| POST STATUTORY CONSULTATION DESIGN UPDATE |                                                                                                                                                                                      |

## A40 SMART CORRIDOR

| SHEET TITLE                        |                        |
|------------------------------------|------------------------|
| DUAL CABINET MEETING OVERVIEW PLAN |                        |
| E1_ZZ_ZZ_ZZ                        | -DR-CH-0608            |

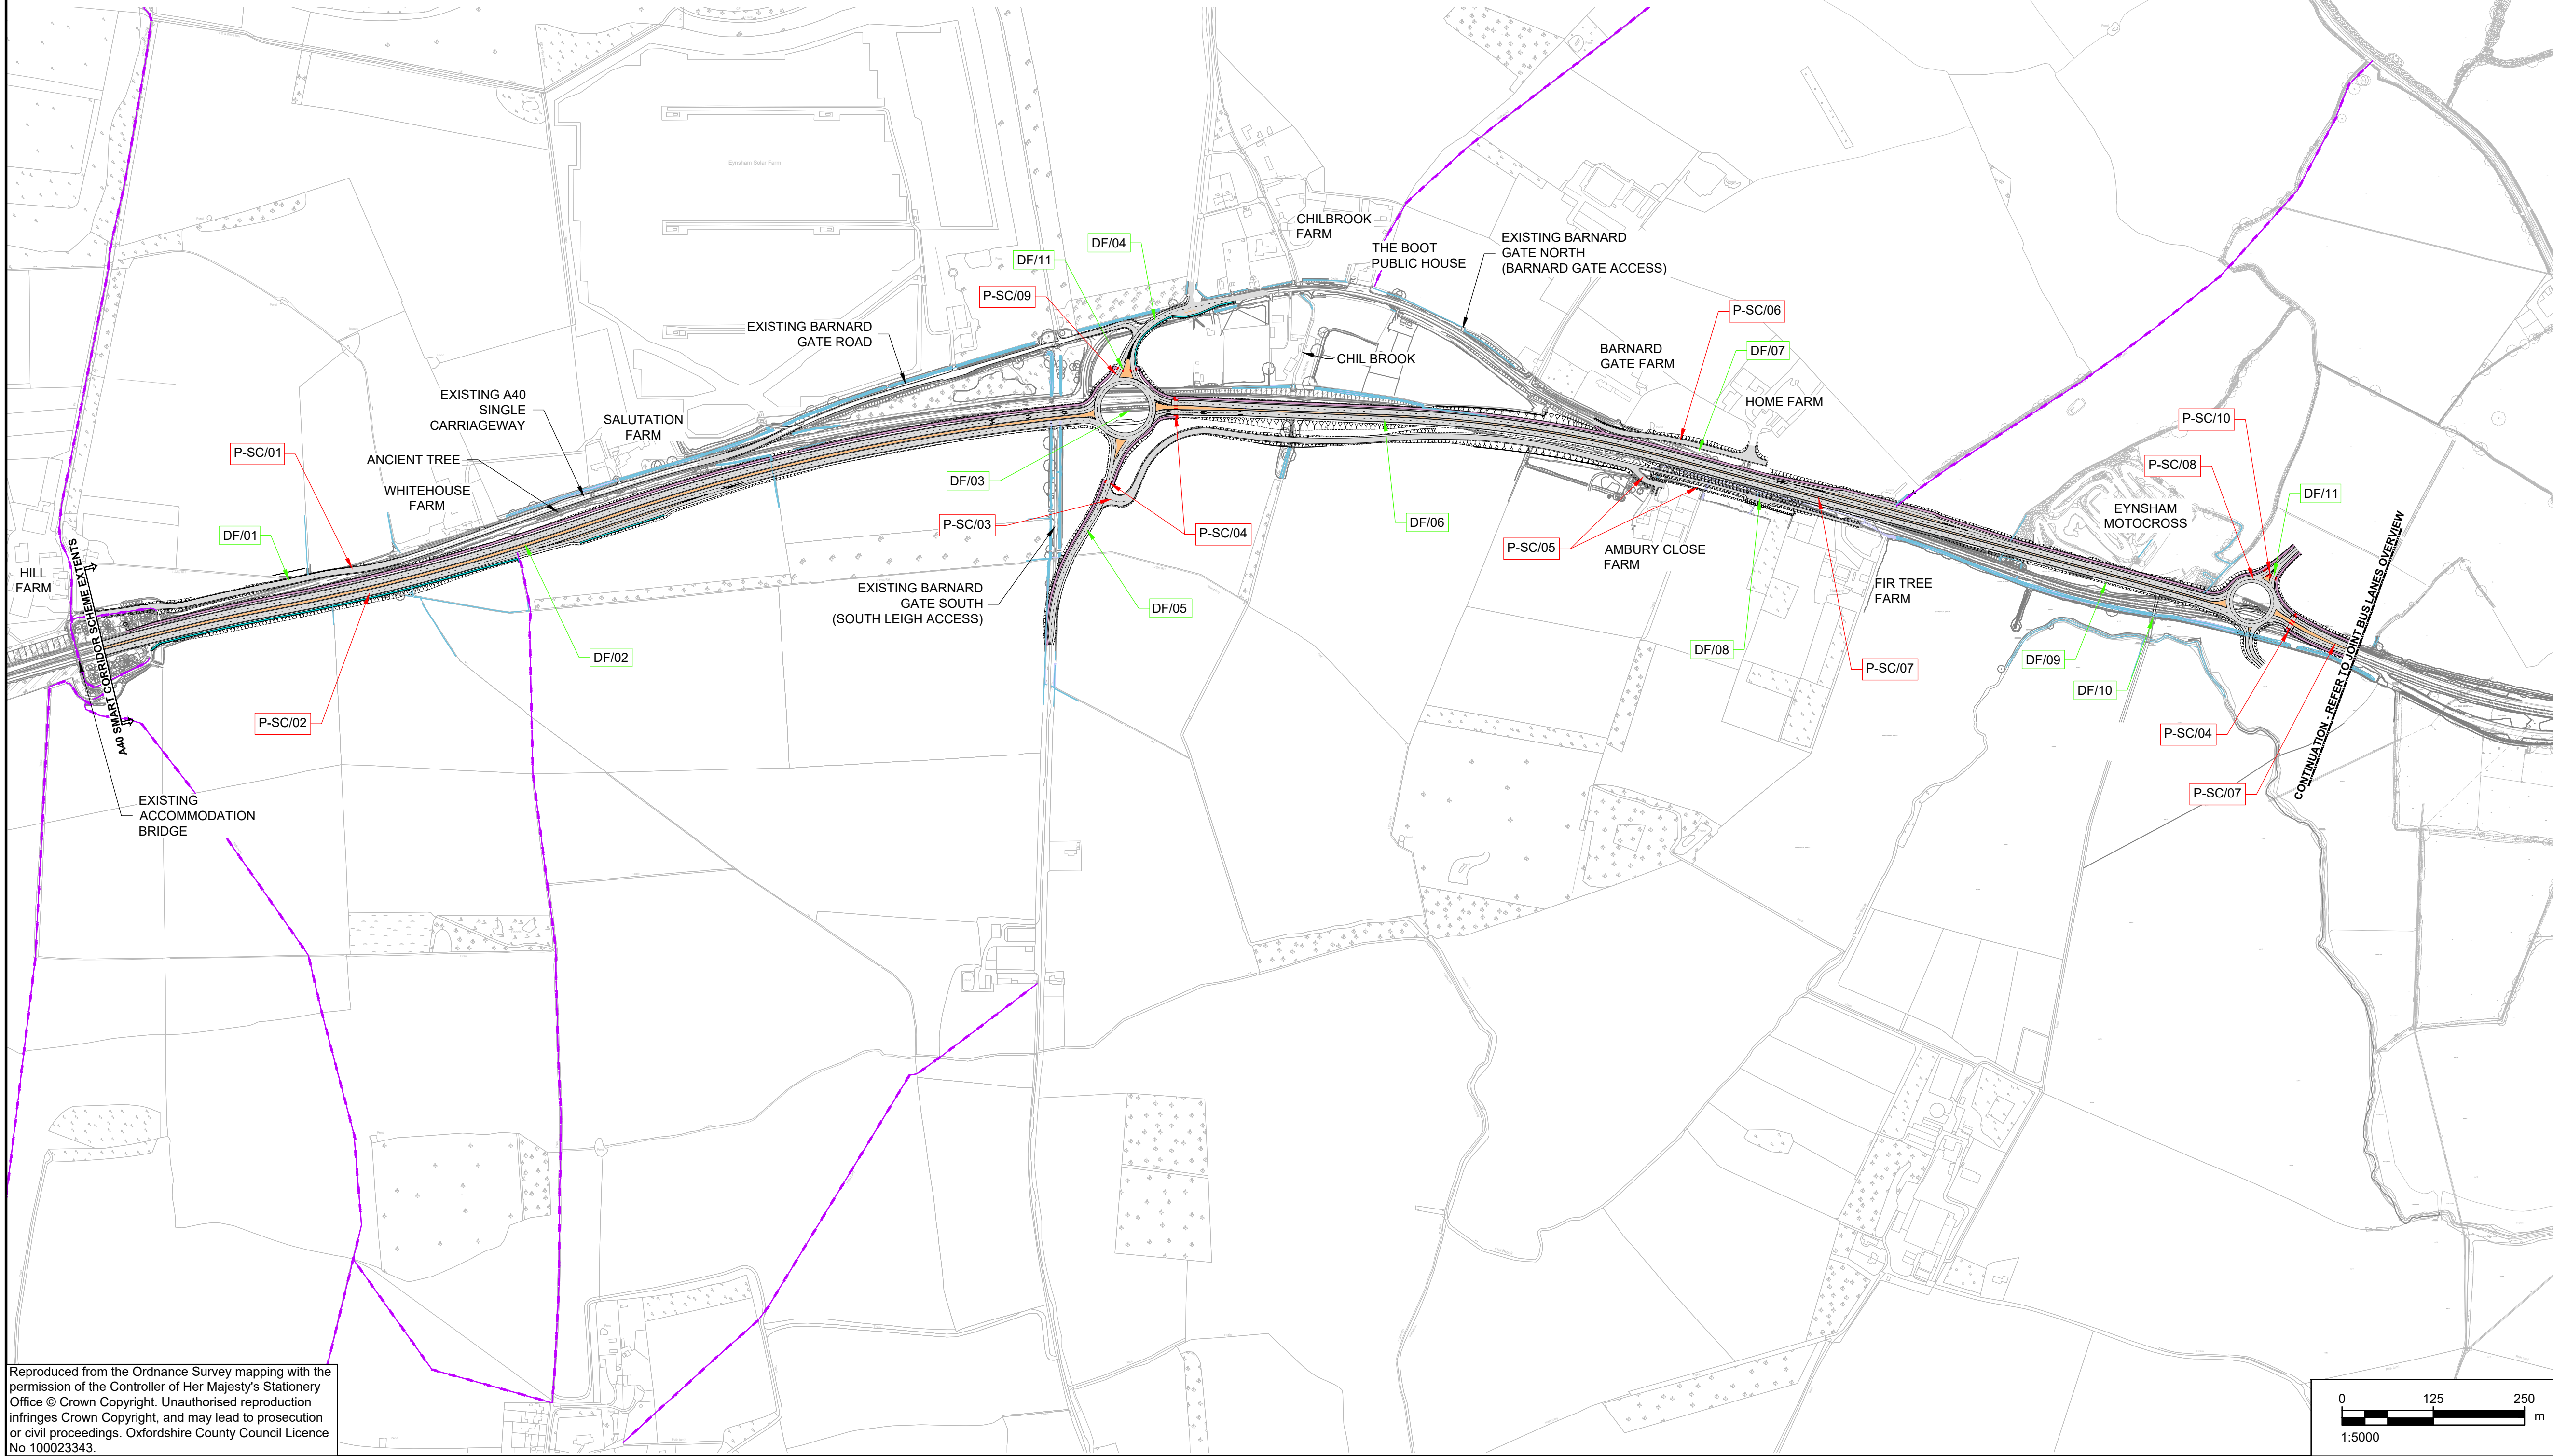
| POST STATUTORY CONSULTATION DESIGN UPDATE |                                                                                                                                                                                      |
|-------------------------------------------|--------------------------------------------------------------------------------------------------------------------------------------------------------------------------------------|
| P-SC/01                                   | LOCAL ACCESS ALIGNMENT REALIGNED TO AVOID EARTHWORKS ENCROACHMENT INTO WHITEHOUSE FARM                                                                                               |
| P-SC/02                                   | A40 DUAL ALIGNMENT REALIGNED AND MOVED SLIGHTLY SOUTH TO AVOID EARTHWORKS ENCROACHMENT INTO WHITEHOUSE FARM.                                                                         |
| P-SC/03                                   | MODIFIED LOCAL ACCESS ROAD AND JUNCTION FOLLOWING LANDOWNER CONSULTATION ON 13 MAY 2021.                                                                                             |
| P-SC/04                                   | TWO TOUCAN CROSSINGS OF THE A40 AT BARNARD GATE JUNCTION, WESTERN ROUNDABOUT AND NEW SOUTH LEIGH CYCLEWAY/FOOTWAY ADDED TO THE DUALLING DESIGN FOLLOWING OCC'S INSTRUCTION (SMI012). |
| P-SC/05                                   | MODIFIED AMBURY CLOSE FARM ACCESS AND INCLUSION OF BUND FOLLOWING LANDOWNER CONSULTATION ON 13 MAY 2021.                                                                             |
| P-SC/06                                   | MODIFIED HOME FARM ACCESS FOLLOWING LANDOWNER CONSULTATION ON 13 MAY 2021.                                                                                                           |
| P-SC/07                                   | A40 DUAL ALIGNMENT (EAST OF BARNARD GATE JUNCTION) CROSS-SECTION NARROWED DUE TO CHANGE IN SPEED LIMIT INSTRUCTED BY SMI023                                                          |
| P-SC/08                                   | WESTERN ROUNDABOUT INCORPORATED INTO THE DUALLING DESIGN FOLLOWING OCC'S INSTRUCTION (SMI005).                                                                                       |
| P-SC/09                                   | NORTHERN ENTRY TO BARNARD GATE ROAD - ROAD ALIGNMENT AMENDED TO CREATE SLOWER VEHICLE APPROACH TO UNCONTROLLED CROSSING                                                              |
| P-SC/10                                   | UNCONTROLLED/CONTROLLED (TBC) CROSSING ON THE NORTHERN ARM OF THE WESTERN ROUNDABOUT                                                                                                 |
| P-SC/-                                    | EARTHWORKS UPDATED FROM 3D MODEL (APPLIES TO ENTIRE SCHEME)                                                                                                                          |
| P-SC/-                                    | DRAINAGE ATTENUATION HAS BEEN AMENDED. THIS IS SHOWN IN THE KEY AS SUDS FEATURE AND SUDS EARTHWORKS                                                                                  |
